Project	IEEE 802.16 Broadband Wireless Access Working Group < http://ieee802.org/16 >	
Title	Modified pilot allocation for 4 BS transmit antennas	
Date Submitted	2004-11-04	
Source(s)	Qinghua Li, Xintian Eddie Lin, Shilpa Talwar Intel Corporation	qinghua.li@intel.com Voice: +1-408-765-9698
Re:		
Abstract	Pilot allocations for 4 transmit antennas in optional FUSC and Band AMC	
Purpose	Adoption of proposed changes into P802.16e Crossed-out indicates deleted text, <u>underlined blue indicates new text change to the Standard</u>	
Notice	This document has been prepared to assist IEEE 802.16. It is offered as a basis for discussion and is not binding on the contributing individual(s) or organization(s). The material in this document is subject to change in form and content after further study. The contributor(s) reserve(s) the right to add, amend or withdraw material contained herein.	
Release	The contributor grants a free, irrevocable license to the IEEE to incorporate material contained in this contribution, and any modifications thereof, in the creation of an IEEE Standards publication; to copyright in the IEEE's name any IEEE Standards publication even though it may include portions

Figure 1 Pilot allocation for 5-antenna BS for the optional FUSC and the optional AMC zones.

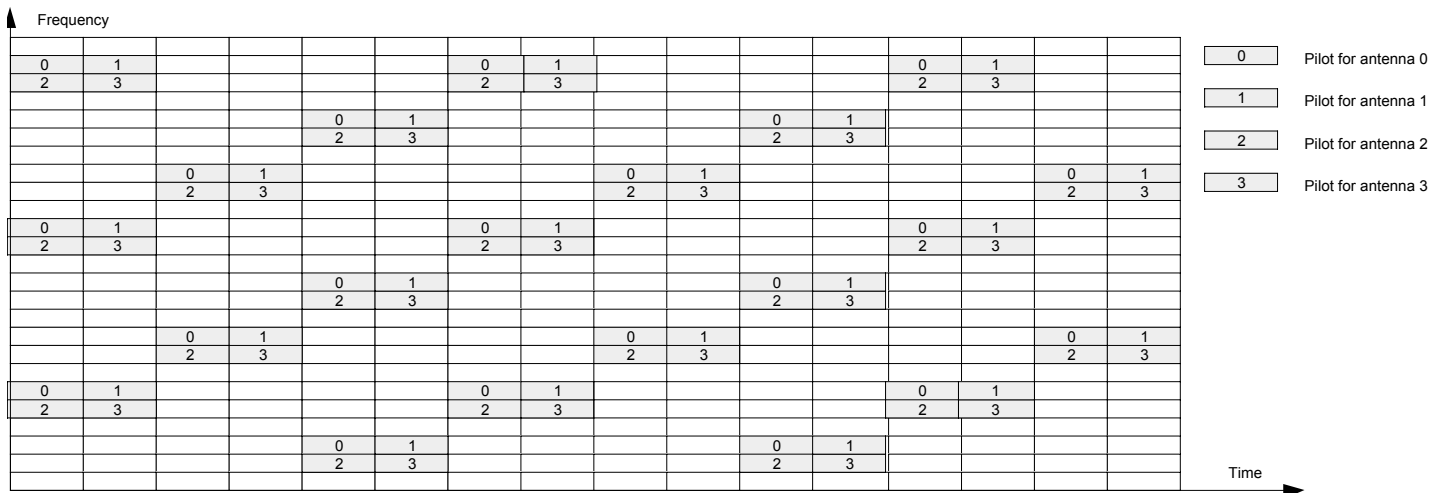
For 4-antenna base station (BS), pilot pattern is shown in Figure 1. The pilots has a periodicity of 9 in frequency axis, and a periodicity of 2 in time axis. The locations of the pilot tone is interleaved to maximize the uniformity of the distribution in freq-time plane. The periodic placement makes the interpolation and tracking easier. The pilot density of each antenna is 1/18.

Figure 251c—Pilot allocation for 4-antenna BS for the optional FUSC and the optional AMC zones

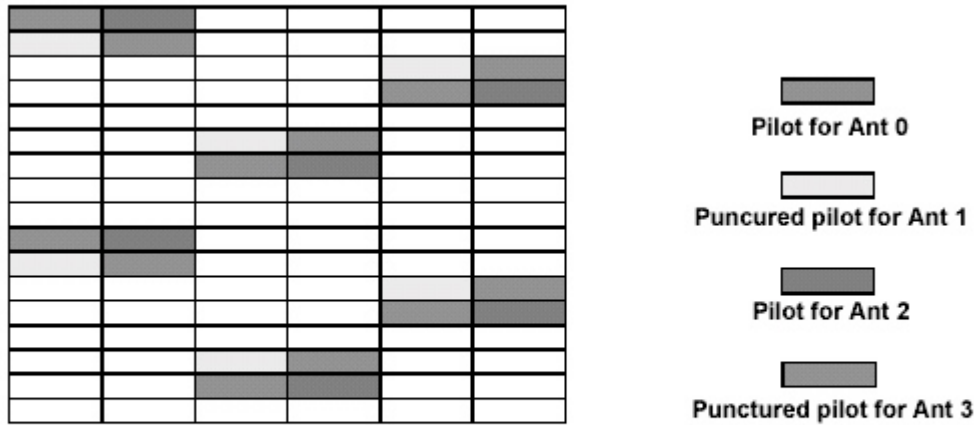
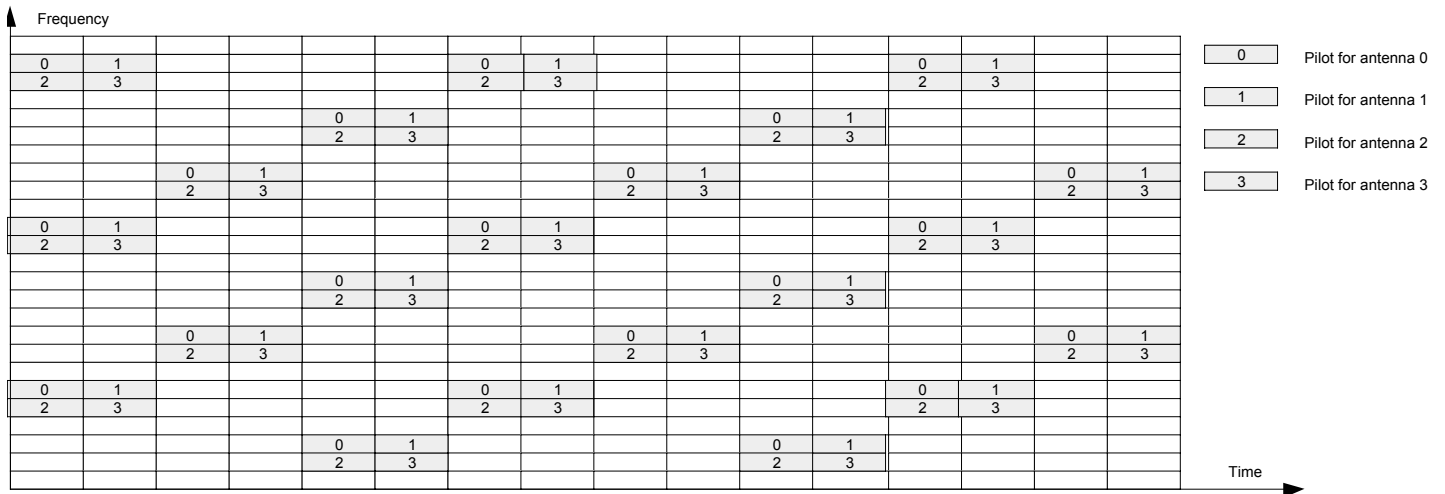
[replace Fig 251c in section 8.4.8.3.2]

[by] For 4-antenna base station (BS), pilot pattern is shown in Figure 1. The pilots has a periodicity of 9 in frequency axis, and a periodicity of 2 in time axis. The locations of the pilot tone is interleaved to maximize the uniformity of the distribution in freq-time plane. The periodic placement makes the interpolation and tracking easier. The pilot density of each antenna is 1/18.
